IFB No. **23-21 Barbour Roof Replacement - Rebid**

RE: **ADDENDUM NO. 1**

RE: CHANGES TO PROJECT MANUAL AND DRAWINGS DATED SEPTEMBER 12, 2022

SUBJECT: RPS 205 BARBOUR ELEMENTARY SCHOOL ROOF
ROCKFORD, IL
ARCHITECT PROJECT #21-13910

1 A-1.0 BARBOUR ELEMENTARY ROOF PLAN
SCALE: 1/16" = 1'-0"

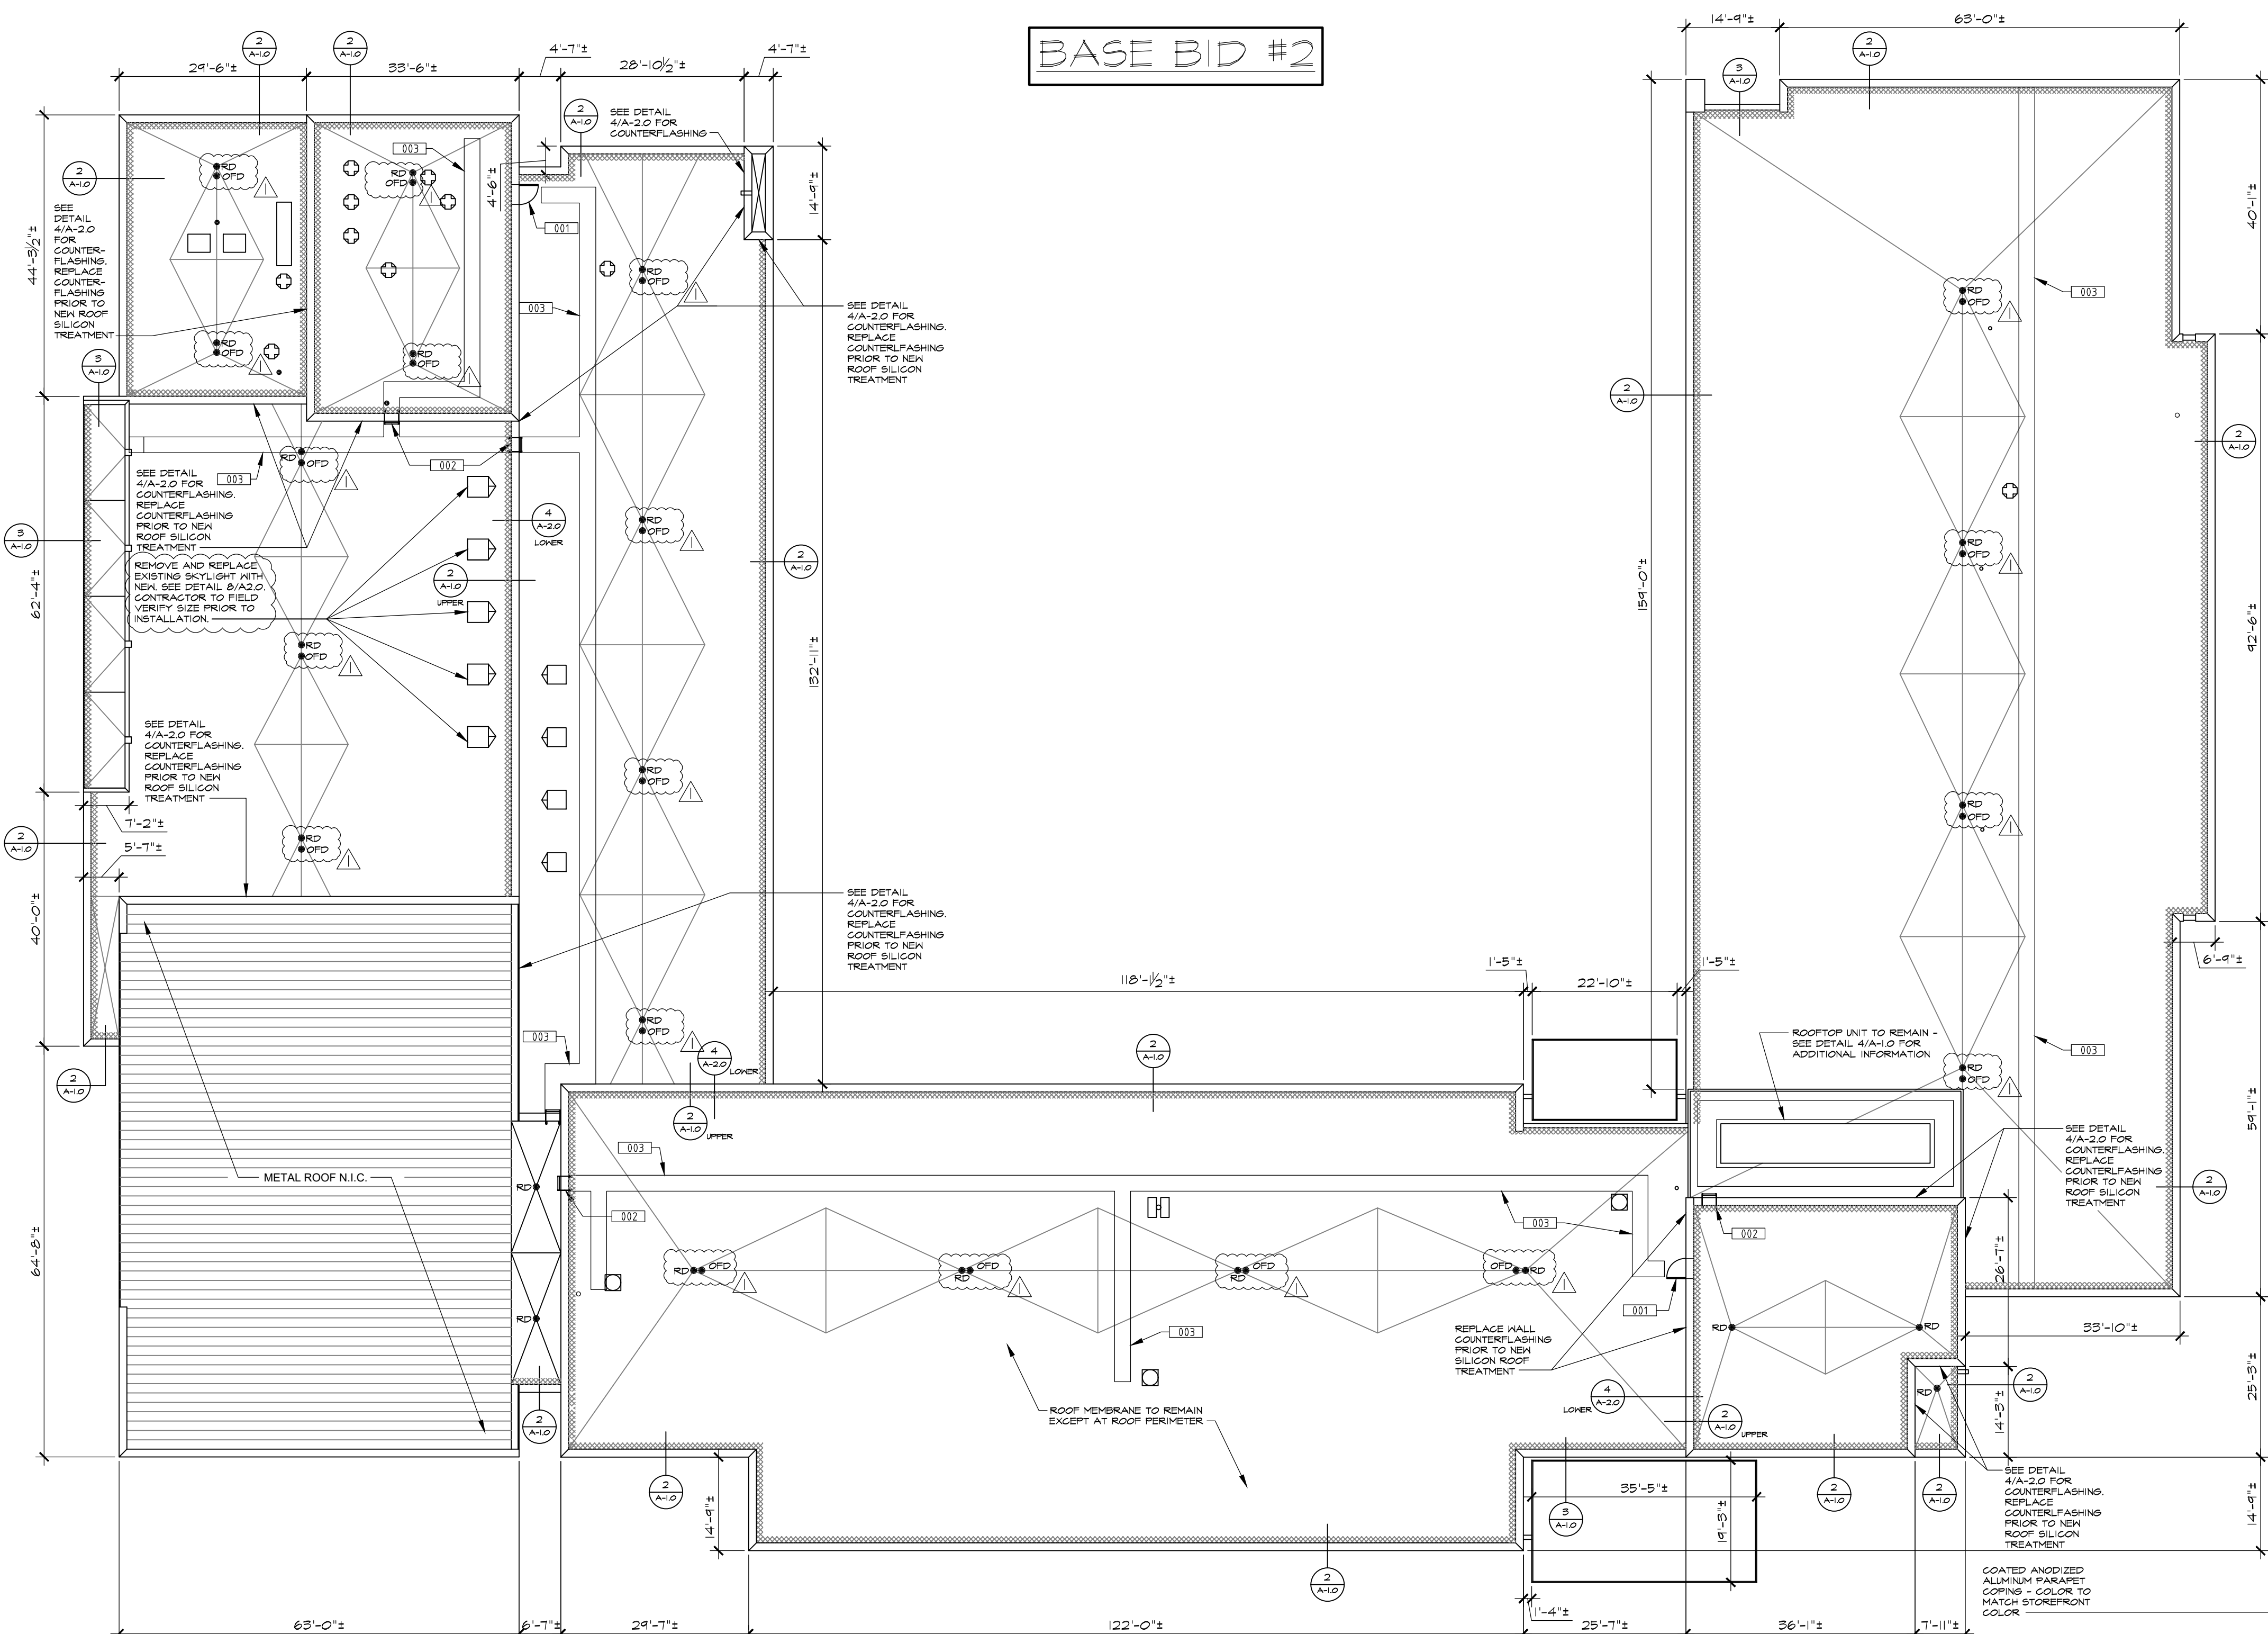
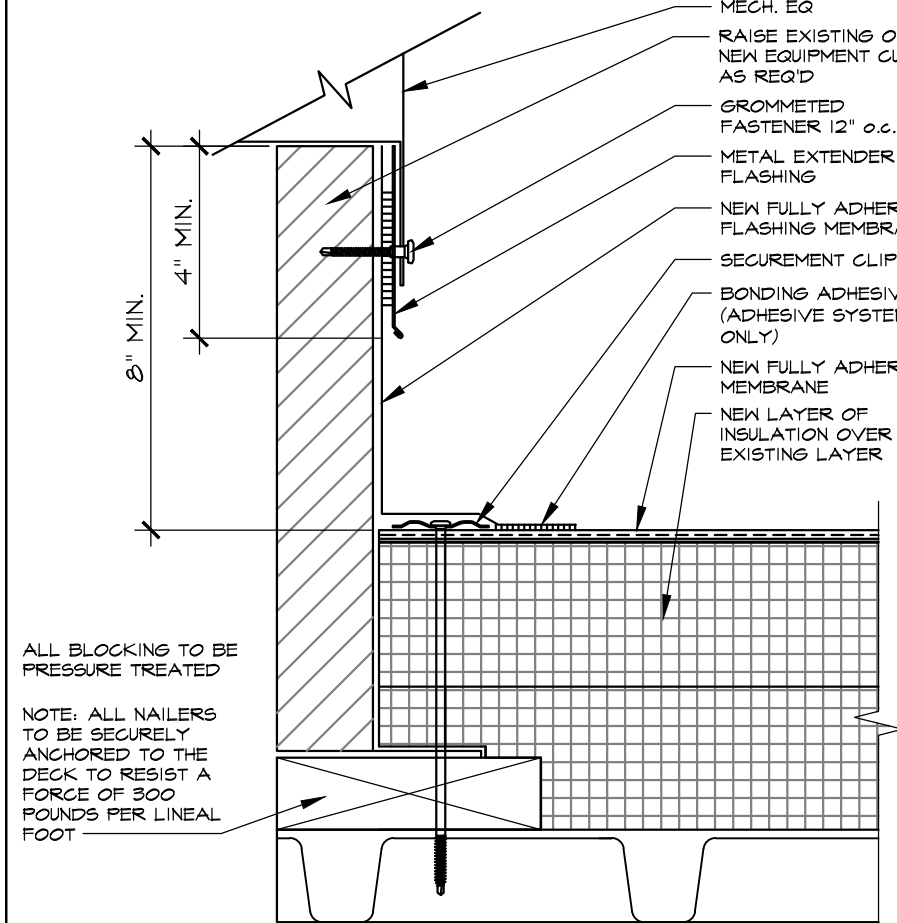
1. **G-1.0:** Revision notation and revision date added.
2. **A-1.0 Base-1:** Notes added to remove and replace existing skylights on roof.
3. **A-1.0 Base-1:** Roof overflow drains called out and noted for 2" minimum clearance from roof.
4. **A-1.0 Base-1:** Two canopy roofs at building entrances are now included in total reroof area.
5. **A-1.0 base-2:** Notes added to remove and replace existing skylights on roof.
6. **A-1.0 base-2:** Roof overflow drains called out and noted for 2" minimum clearance from roof.
7. **A-1.0 base-2:** General Note 10 changed allowance of damaged roof insulation from 2% to 900 square feet for bidding.
8. **A-1.0 base-2:** Keynote 003 re-written to: "Roof walkway path to match the same as existing. New path to be different color than roof coating. Width of walkway to be 30"
9. **A-2.0:** Roof hatch detail (8) was removed and replaced with skylight details.
